**Proposal for 03 series of amendments to Regulation No. 117 –
Proposal based on ECE/TRANS/WP.29/GRB/2012/15 and
ECE/TRANS/WP.29/GRB/2012/18**

The text reproduced below was prepared to amend UNECE Regulation 117 in order to allow the use of the test track complying to ISO 10844:2011 with transitional provisions.

Figure 1
Minimum requirements for test surface area. The shaded part is called "Test Area"

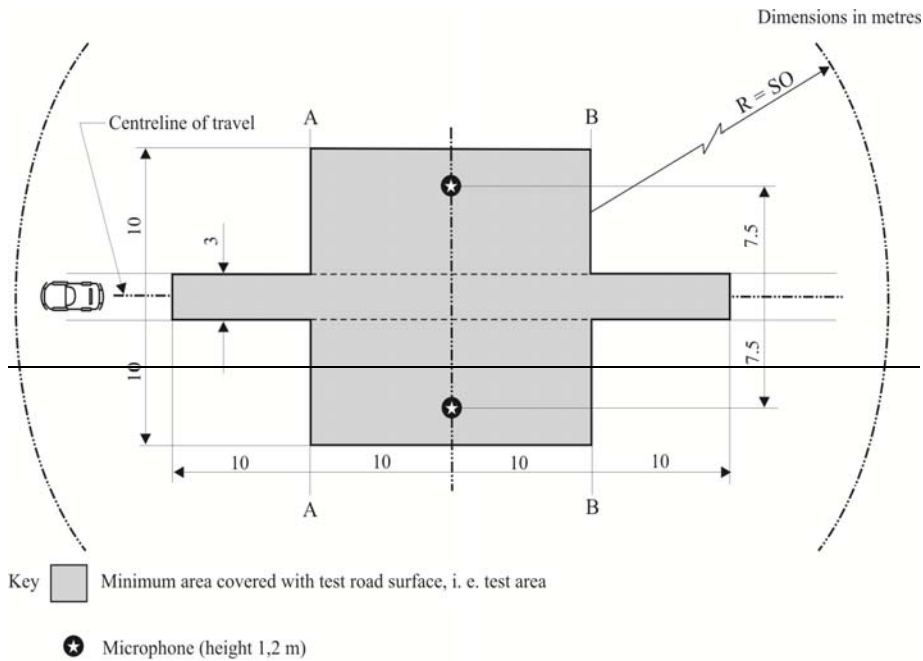
~~For the purpose of this measurement, cores have to be taken from the track in at least four different positions, which are equally distributed in the test area between lines AA and BB (see Figure 1). In order to avoid inhomogeneity and unevenness in the wheel tracks, cores should not be taken in wheel tracks themselves, but close to them. Two cores (minimum) should be taken close to the wheel tracks and one core (minimum) should be taken approximately midway between the wheel tracks and each microphone location.~~

~~If it is necessary to repave the test track, it is usually unnecessary to repave more than the test strip (of 3 m width in Figure 1) where vehicles are driving, provided the test area outside the strip met the requirement of residual voids content or sound absorption when it was measured.~~

Figure 2

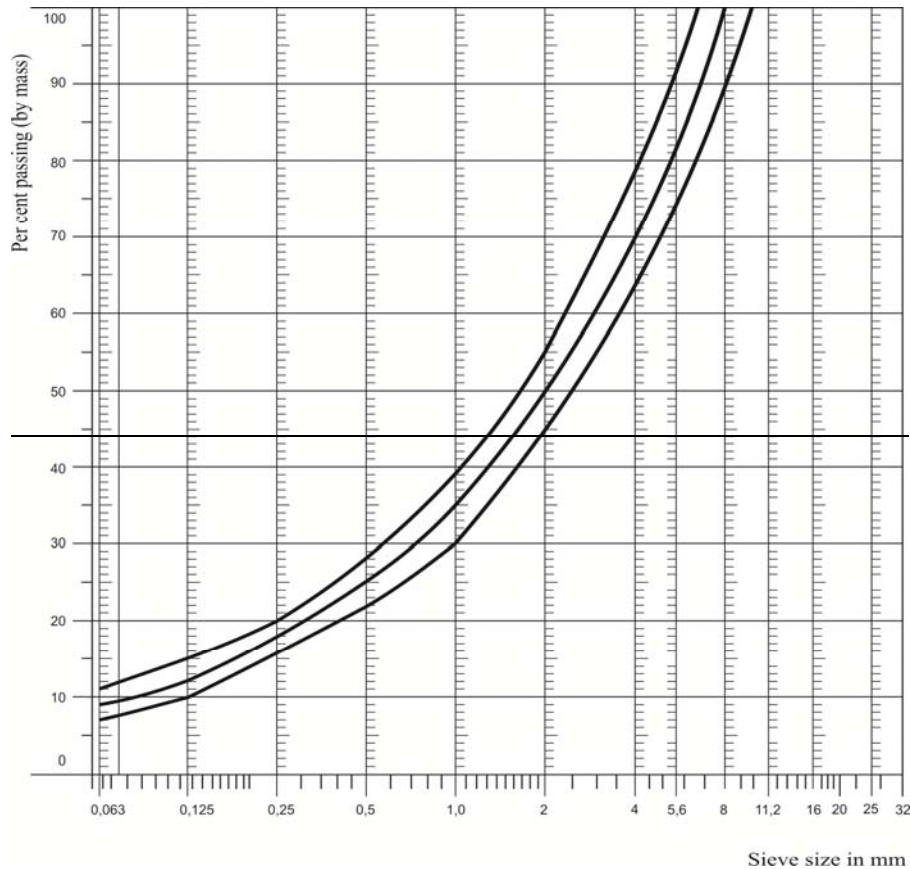
————— As a guide to the surface constructor, an aggregate grading curve which will give desired characteristics is shown in Figure 2. In addition, Table 1 gives some guidelines in order to obtain the desired texture and durability. The grading curve fits the following formula:

Figure 1
Size of the test track

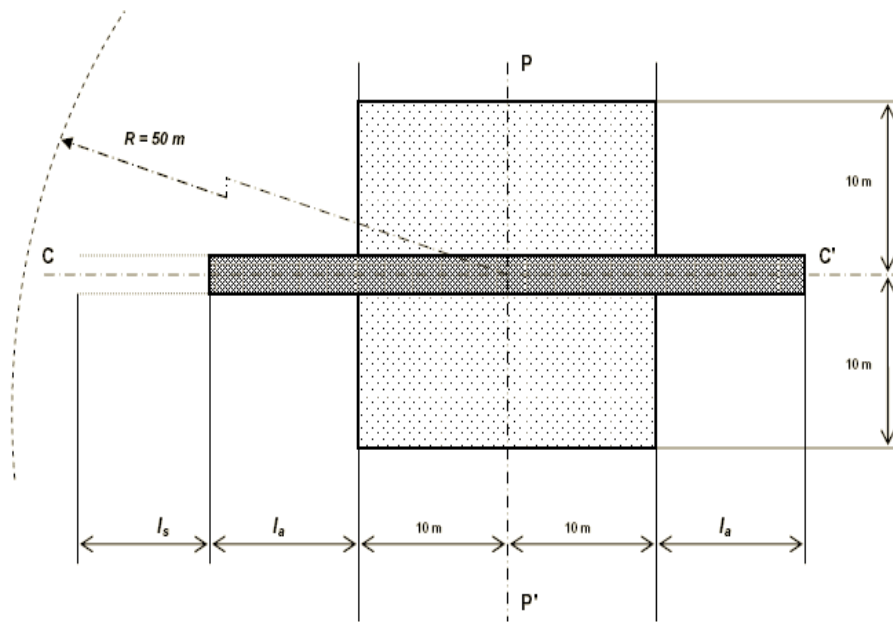
A drive lane with a length of l_a and width of at least 3.0 m that is centered around line PP'. The value of l_a is defined in Table 1.

The propagation area shall extend at least 10 m from the centre of the drive lane and at least 10 m at both sides of the line PP'.

The space around the centre of the track within a radius of 50 m shall be free of large reflecting objects such as fences, rocks, bridges or buildings.

Figure 2
Propagation area slope in transverse direction

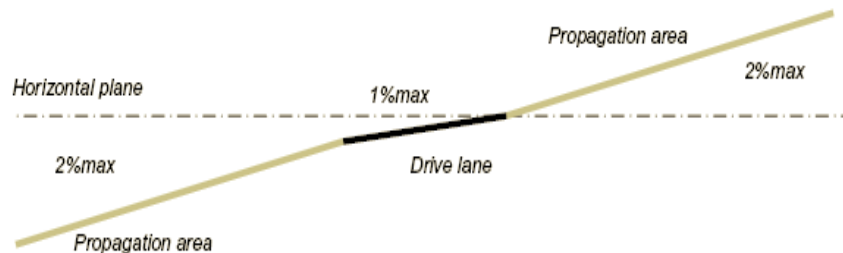
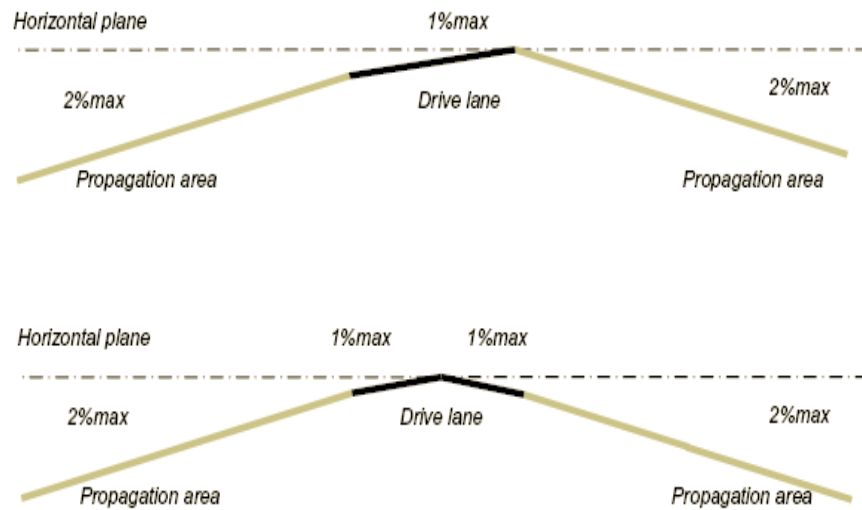
- (i) For acceptance of the test track only, transverse irregularities equal to or less than 0.003 m and longitudinal irregularities equal to or less than 0.002 m measured with the straightedge according to EN 13036-7;
- (ii) For periodical checking of the test track only, transverse irregularities equal to or less than 0.005 m and longitudinal irregularities equal to or less than 0.005 m measured with the straightedge according to EN 13036-7;
- (iii) For acceptance only, deviation from the horizontal plane in transverse direction of 1.0 per cent maximum (see Figure 2) and in a longitudinal direction of 0.5 per cent maximum.

- (i) The propagation area shall have irregularities equal to or less than 0.02 m measured with the straightedge according to EN 13036-7;
- (ii) The propagation area may have one or both sides lower than the drive lane. Cross fall in transverse direction, measured using an appropriate instrument, shall be equal or less than 2.0 per cent (see Figure 2);

Figure 3
Propagation area – Steps or discontinuities

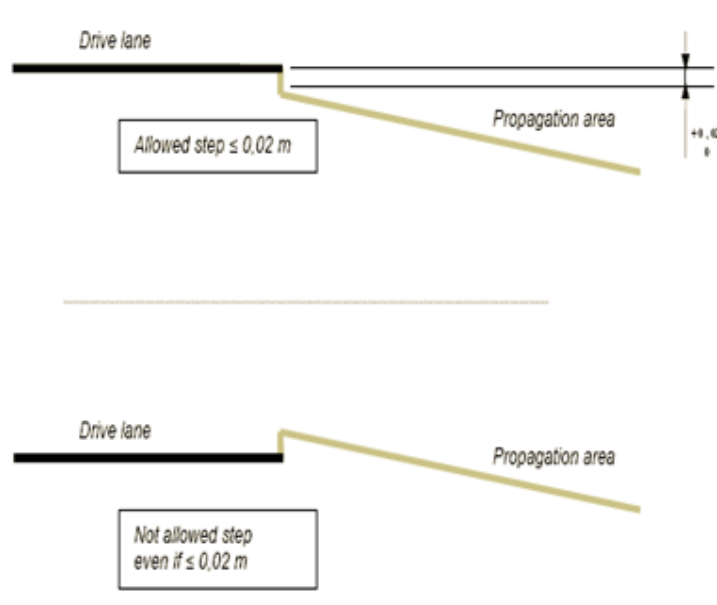
Steps or discontinuities between the propagation area and the drive lane shall be between 0 and +0.02 m. Negative steps are not allowed (see Figure 3).

Figure 4
Sieving curve area

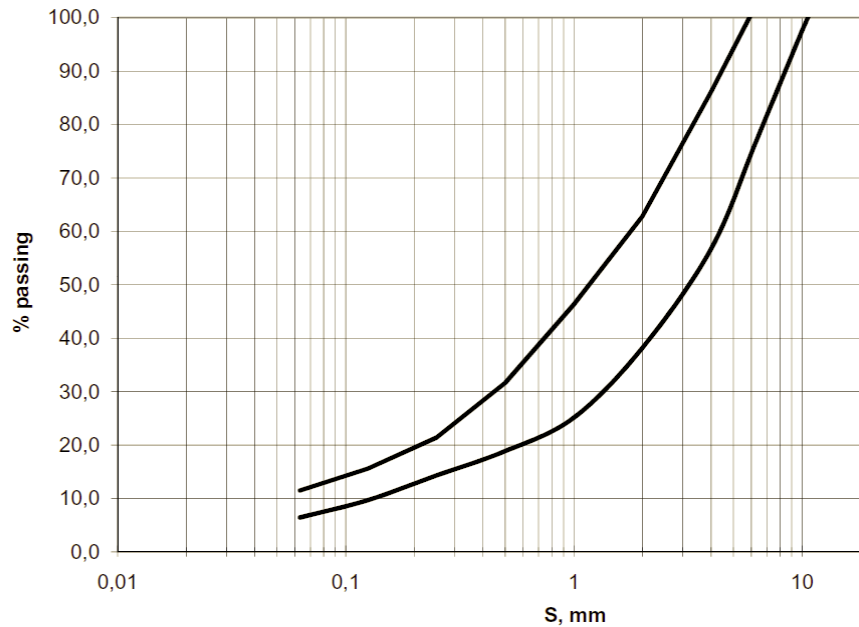
- (a) be of dense asphalt concrete;
- (b) exhibit a sound absorption equal to or less than 8 per cent in any one-third-octave band between 315 Hz and 1 600 Hz when measured according to 4.3;
- (c) have a maximum chipping size of 8 mm (tolerance allowed between 6.3 mm to 10 mm);
- (d) have a thickness of the wearing course greater than or equal to 30 mm;
- (e) have a Mean Profile Depth measured according to ISO 13473-1 of $0.5 \text{ mm} \pm 0.2 \text{ mm}$;
- (f) have a target sieving curve for the aggregate as shown in Figure 4.

Figure 5
Measurement positions on test track, example for $l = 40$ m

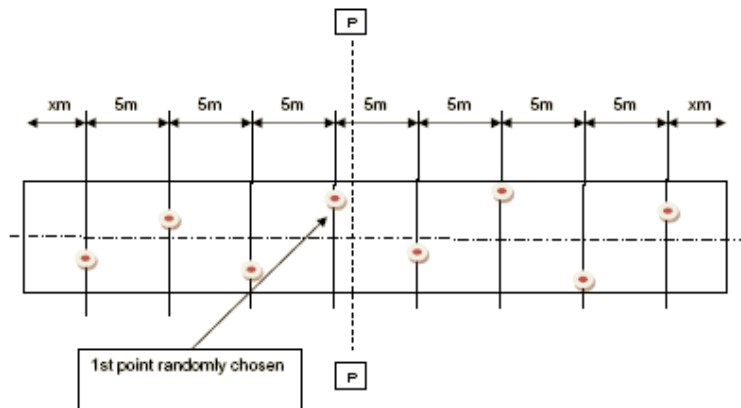
- (c) All measurements shall be made along the total length of the drive lane in each wheel track according to the following scheme to Figure 5;
- (d) For sound absorption, texture, geometrical compliance, the first test point shall be chosen randomly on each side in the vicinity of the line PP' and the subsequent measurements shall be performed at 5 m intervals not on the same axis of the centre line to cover the whole track;
